**Wickenburg Downtown Flooding Hazard
Mitigation Project
(FCD #2006C018)
CLOMR
FEMA Case No. 07-09-0738R**

**Response to
FEMA Review Comments of
April 17, 2007**

IN REPLY REFER TO:
Case No.: 07-09-0738R

Matchline Sheet 10

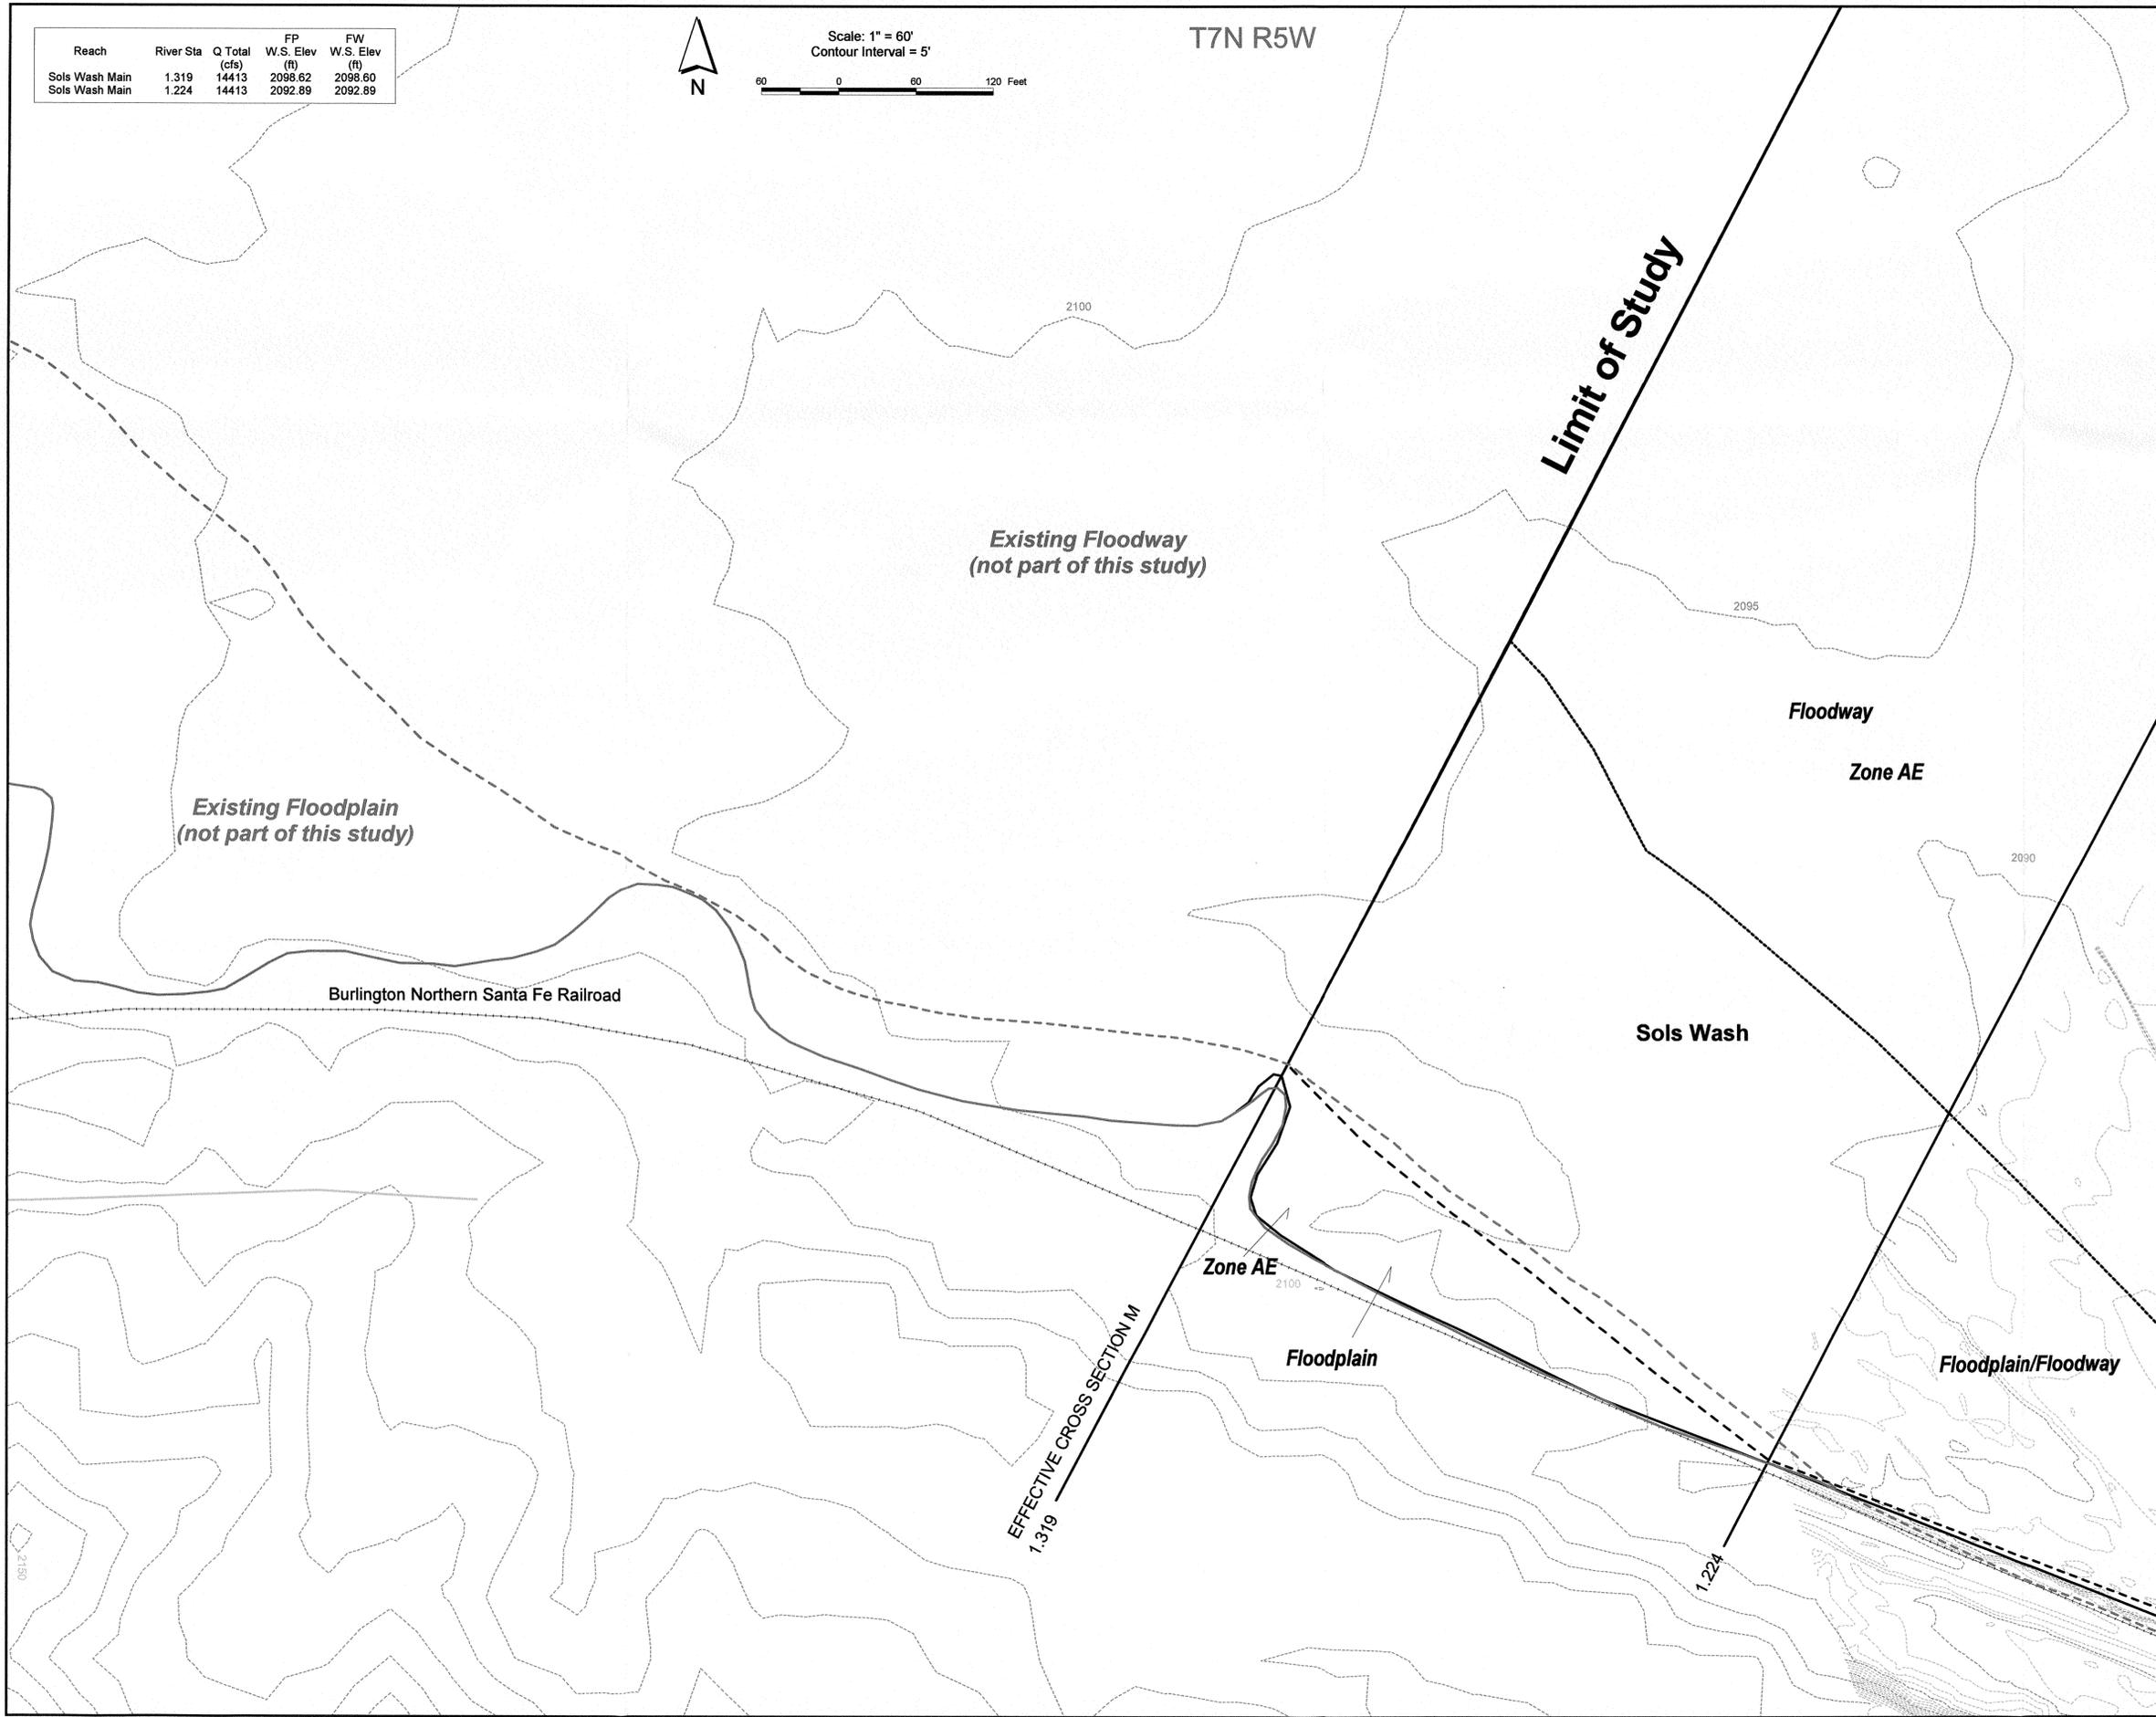
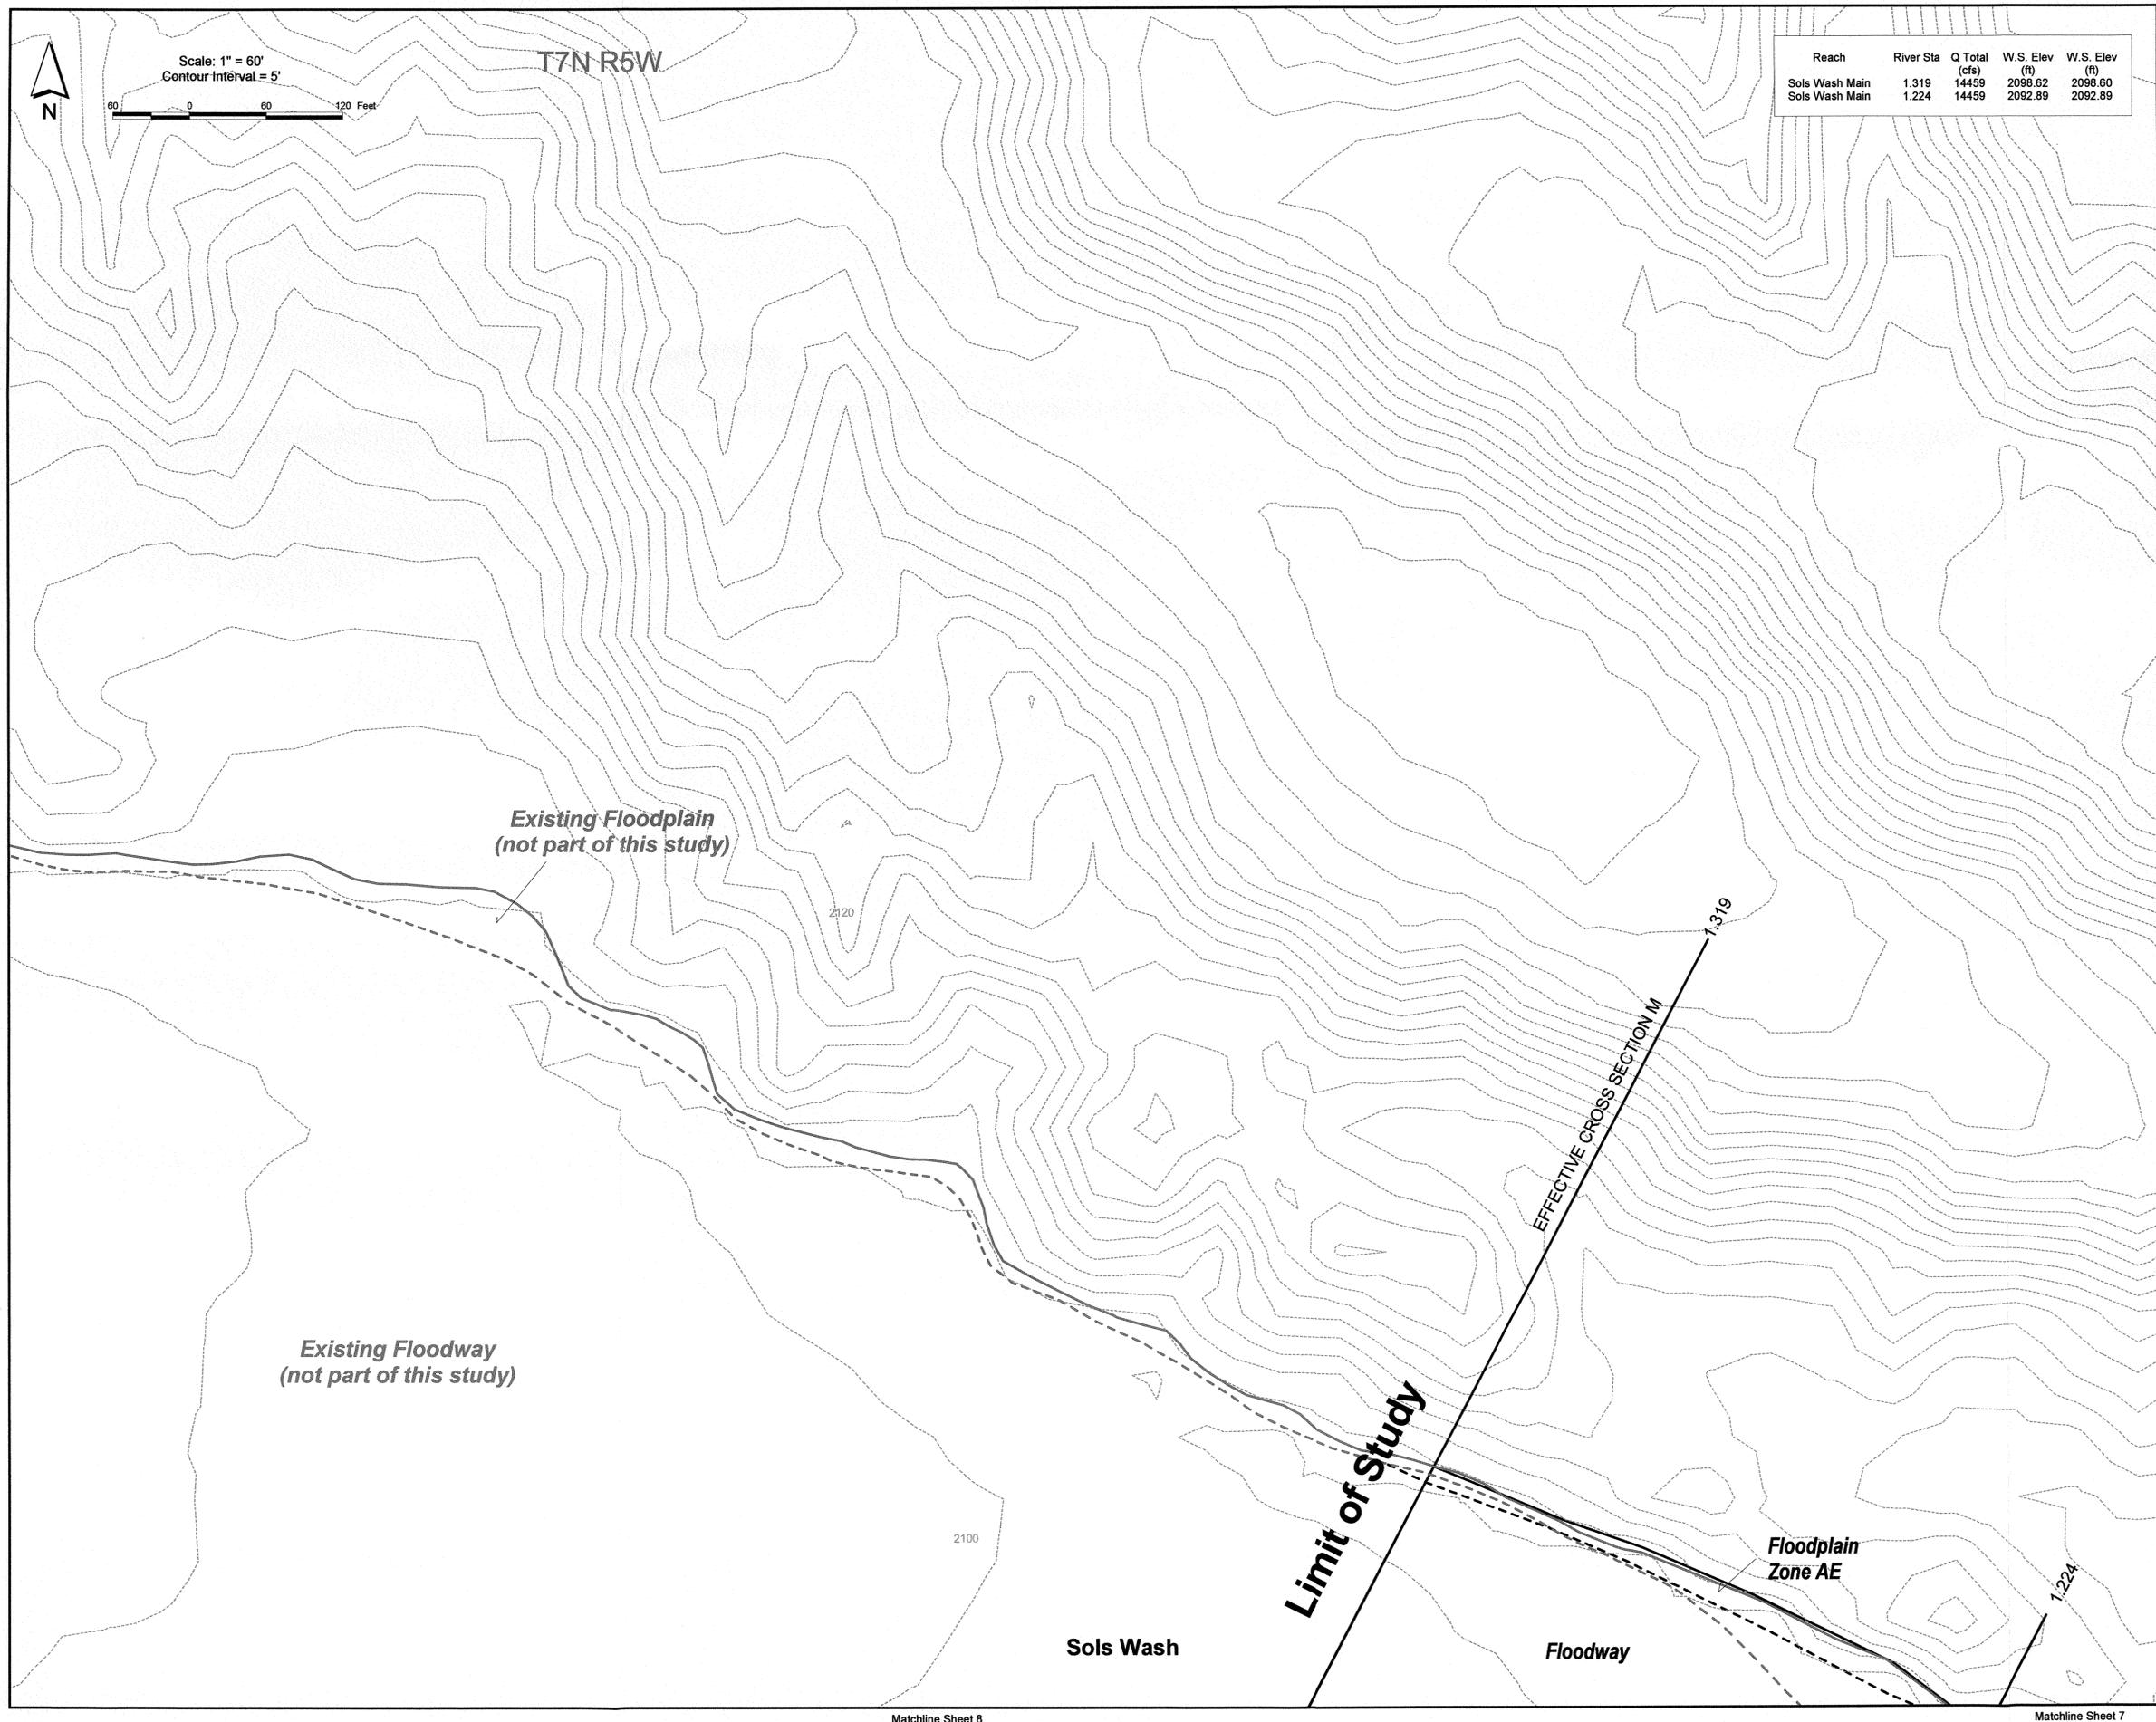
9. The above-mentioned topographic work maps do not provide essential information required to complete our detailed review of this request. Please provide the following information, which was omitted from the submitted topographic work maps.

- (a) Boundary delineations of the currently effective base floodplain and floodway
- (b) Boundary delineation of the existing conditions base floodplain
- (c) Existing conditions topographic contour information, including the topographic information that has been altered by the existing floodwall and Goldmine Village improvements
- (d) Proposed conditions topographic contour information, including topographic information that will be altered by the proposed levee, which can be used to verify the boundary delineation of the base floodplain
- (e) Please submit both a hard copy and a digital copy of all work maps

9. Revised work maps are enclosed.
 - a) The effective floodplain/floodway limits have been added to the workmaps.
 - b) The existing conditions floodplain was not studied under this project as the overall intent of this project is to channelize the Sols Wash floodplain, thereby, greatly reducing the limits of the floodplain. Based on topographic information developed for this study and that for the original FEMA study for Sols Wash, however, there is no reason to expect any significant difference between a current "existing" conditions floodplain and that of the effective study. The only exception to this is in the north overbank area where flows on the west side of Tegner Street are likely to cross over the roadway into the north overbank area on the east side of Tegner St. This is not reflected in the effective delineation even though the original FEMA study workmaps indicated that flow elevations were such that 100-YR flows might overtop Tegner St. An existing conditions study, which addressed the flows overtopping Tegner, was performed under the Goldmine Village request for a CLOMR, submitted to and approved by FEMA.

per the CLOMR. Some additional fill is required on the site to meet the CLOMR geometry. The Wickenburg Downtown Project will provide that fill. The proposed grading for the property has been added to the workmaps. The existing conditions topo shown on the submitted work maps is as the site currently exists today. Pre-fill topographic data is available in the Goldmine Village CLOMR. Please note: there is no existing floodwall on the Goldmine Village property.

- d) Proposed topographic contours have been added to reflect the proposed fill on the Goldmine Village property. Additional contours have been added where practical. Please note, in areas of vertical floodwalls, contours cannot be shown. In these areas, please refer to the cross section plots. Some revisions, to correct some minor discrepancies, have been made to several of the cross section sheets since the original submittal. Please see the revised plots in the design plan set.
